ADDENDUM NO. 1

Additions & Renovations to Pleasant Run Elementary School
1800 North Franklin Road
Indianapolis, IN 46219

PROJECT: PLEASANT RUN ELEMENTARY SCHOOL RENOVATION & ADDITION

PROJECT NO: 2020061

3 CAFE AREA FRAMING PLAN - CALLOUT
1/4" = 1'-0"

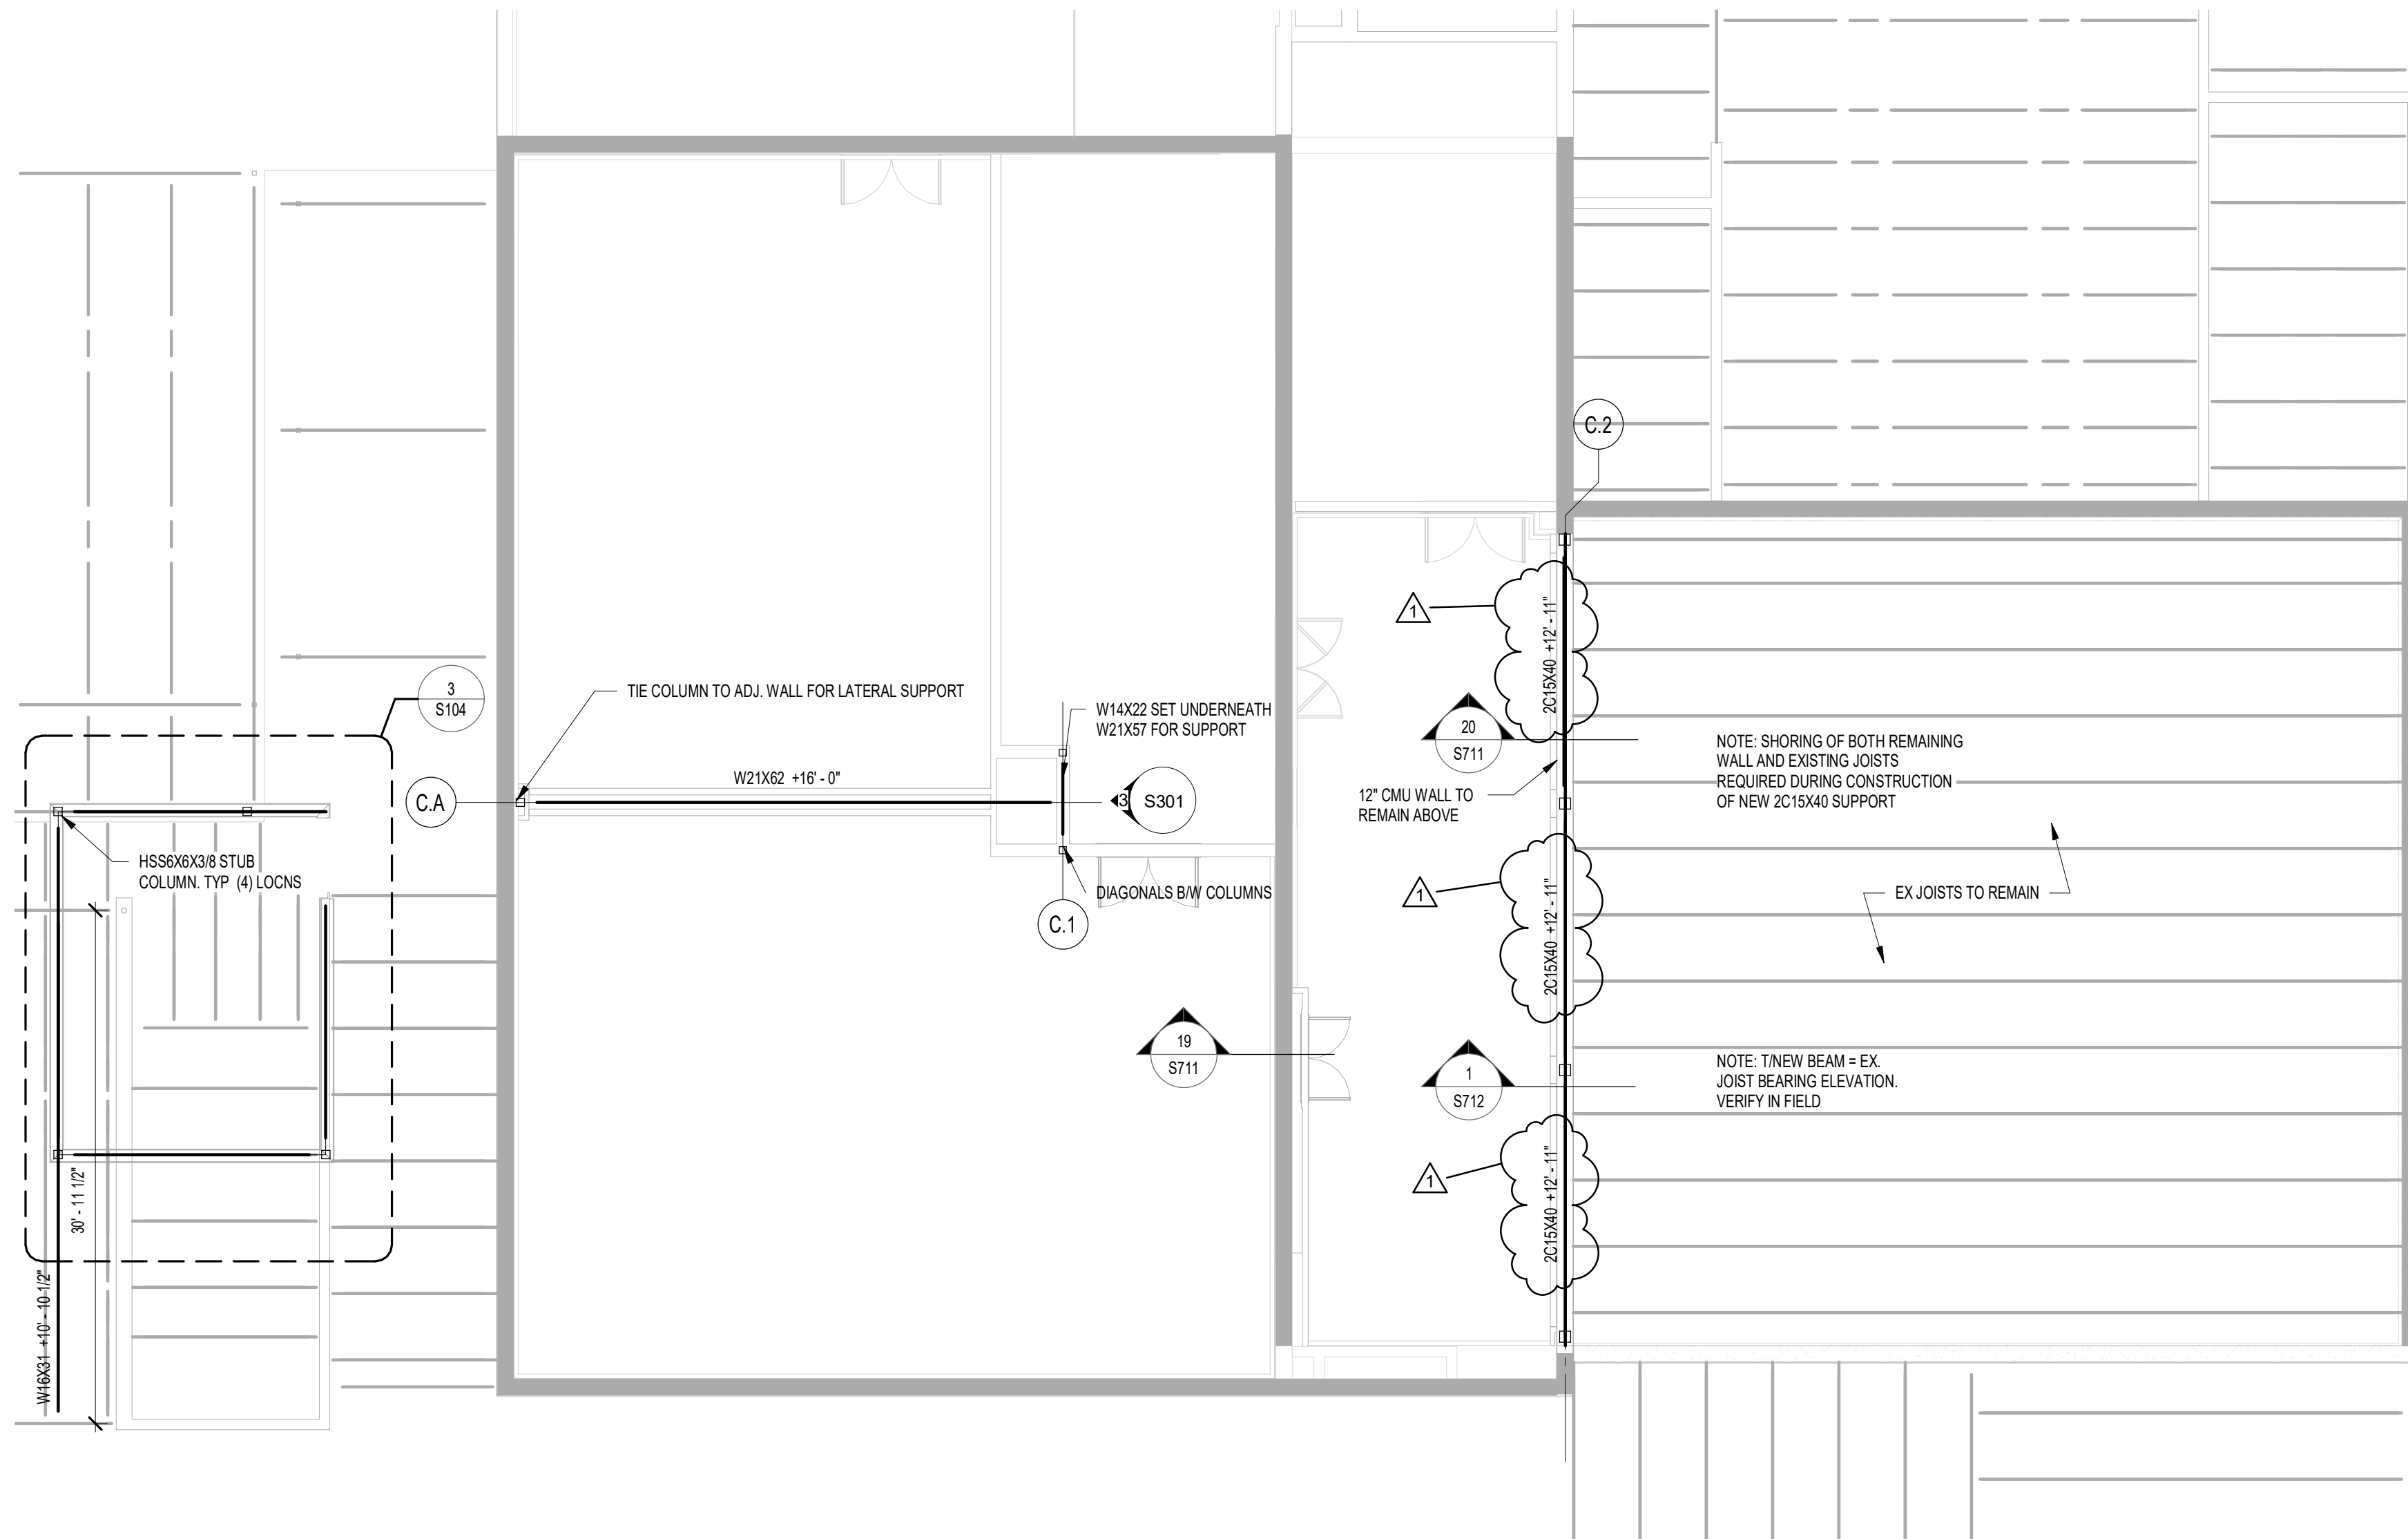
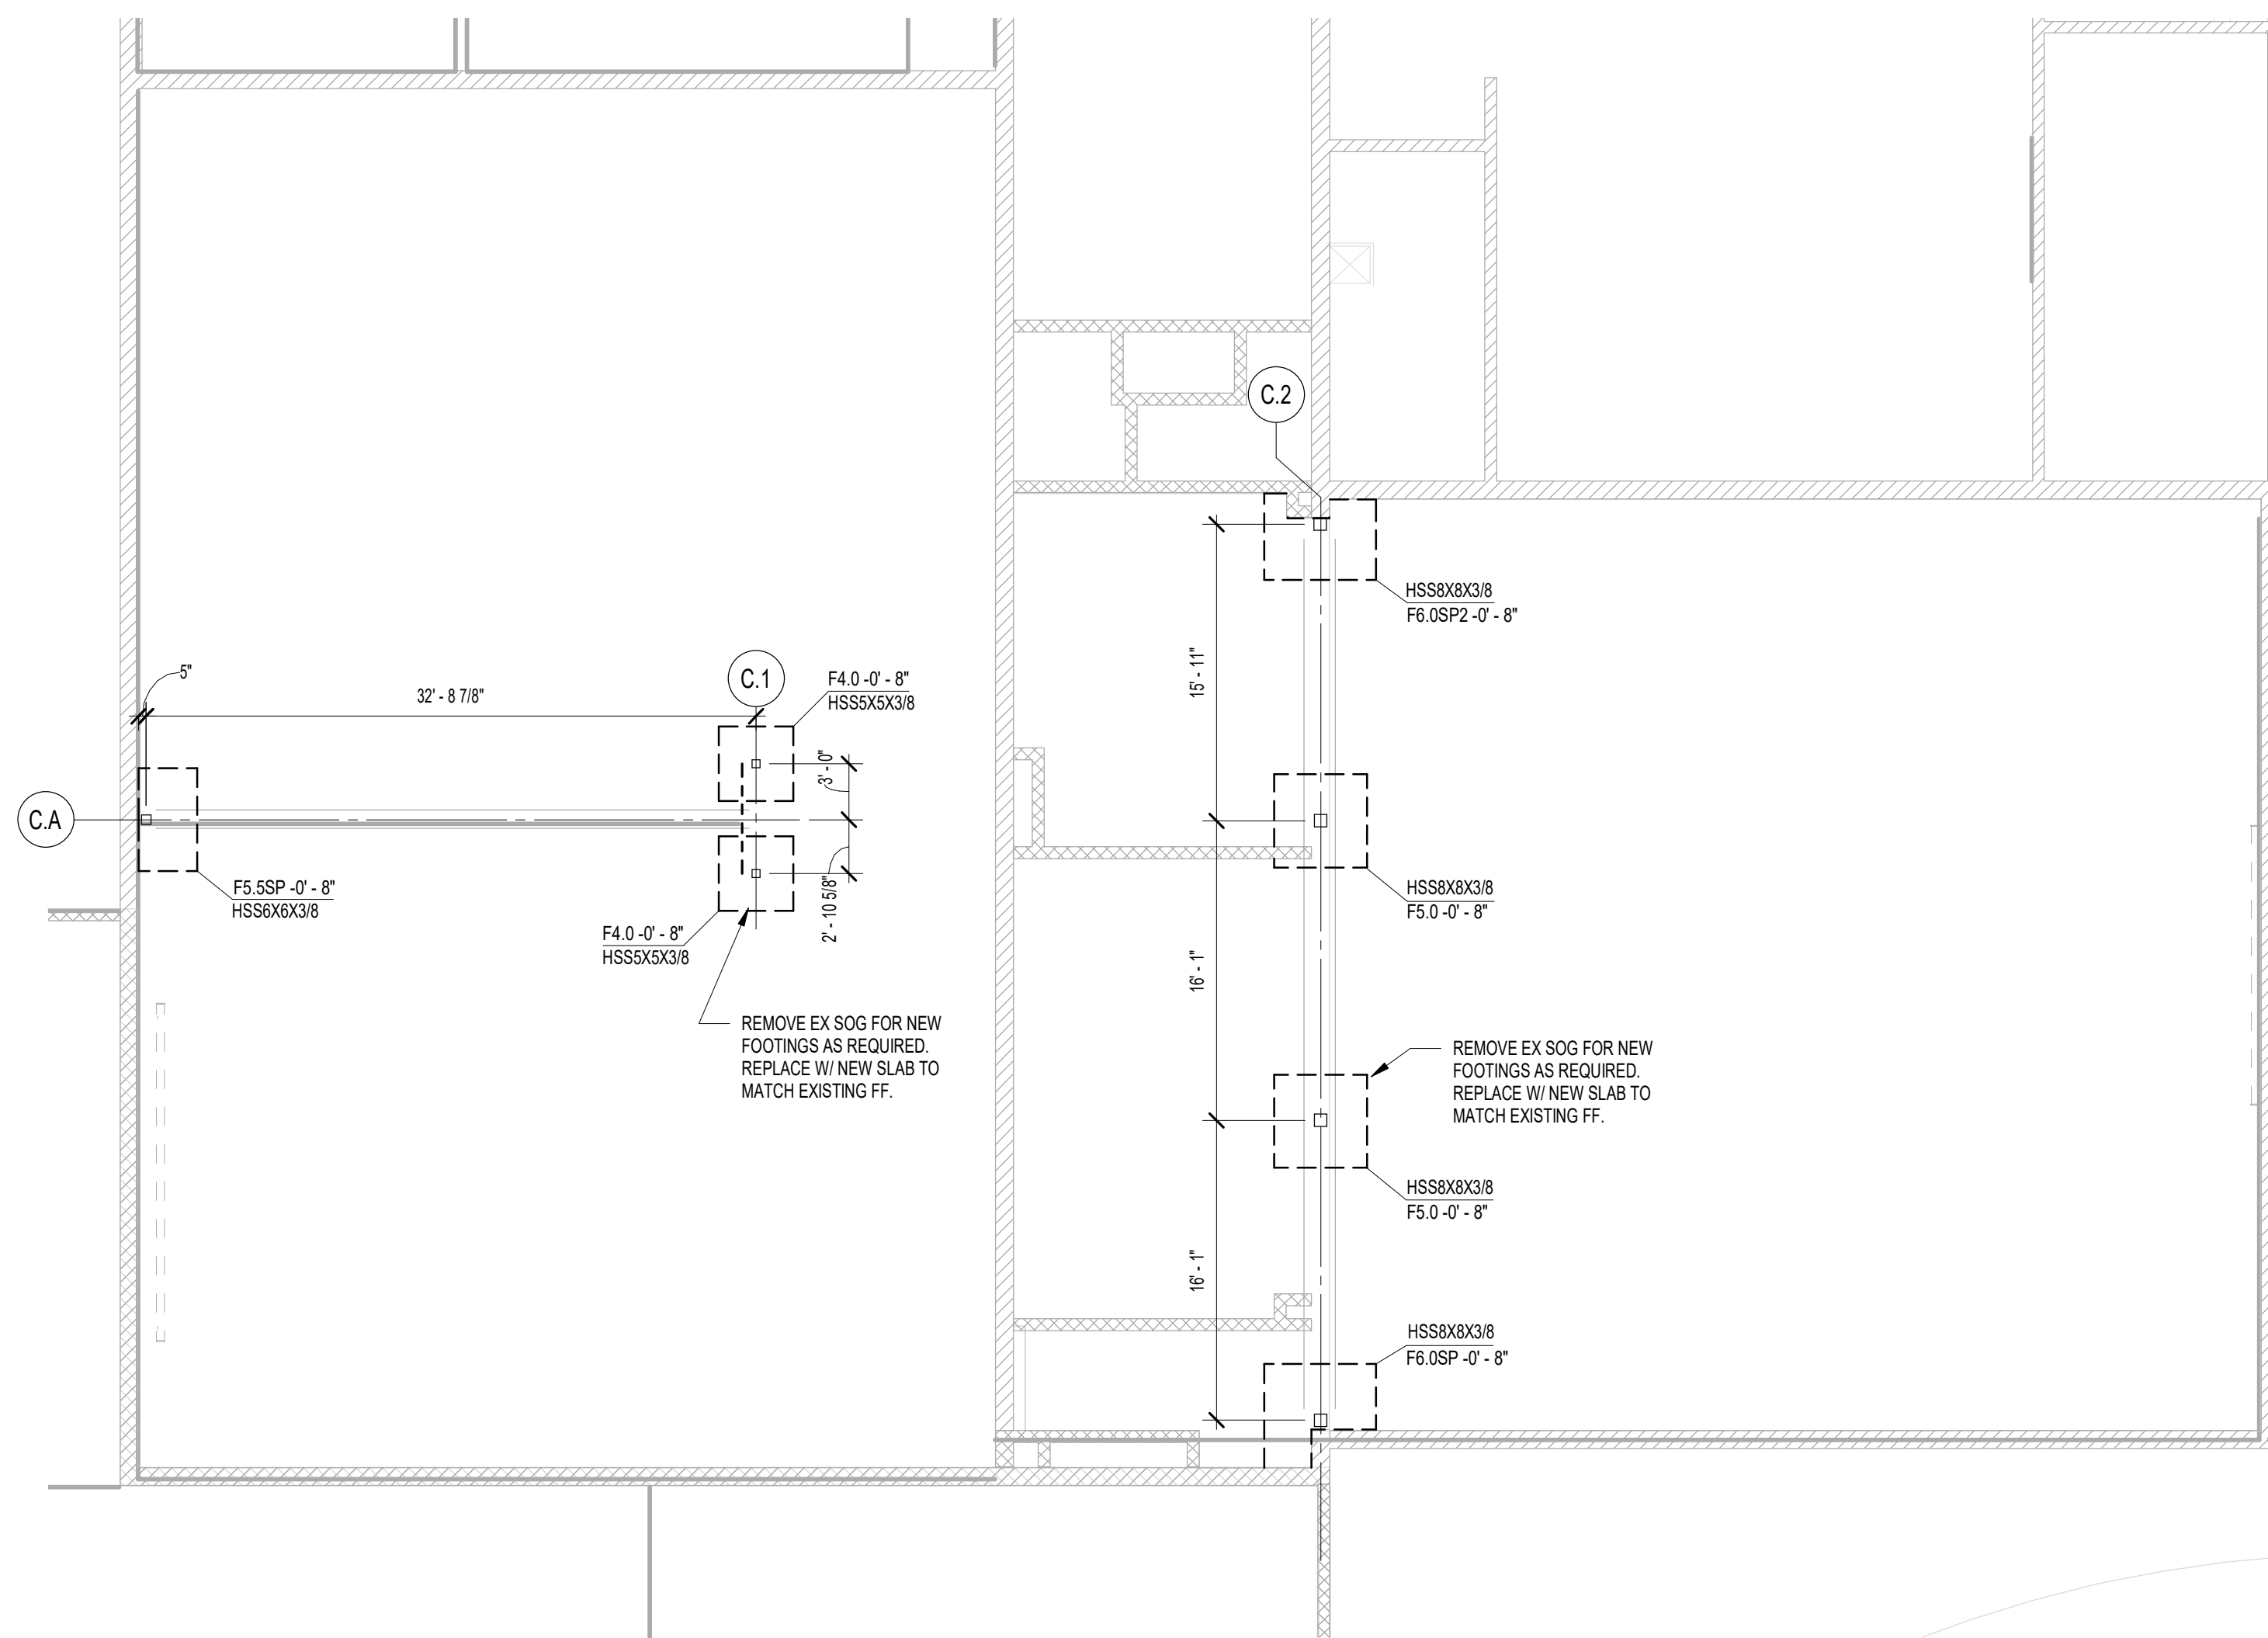
Drawing S104 Café Foundation and Framing Plans Unit C

1. Modified T/S elevation of 2C15x40 wall support beam.
2. Modified screen wall dimensions on existing roof.
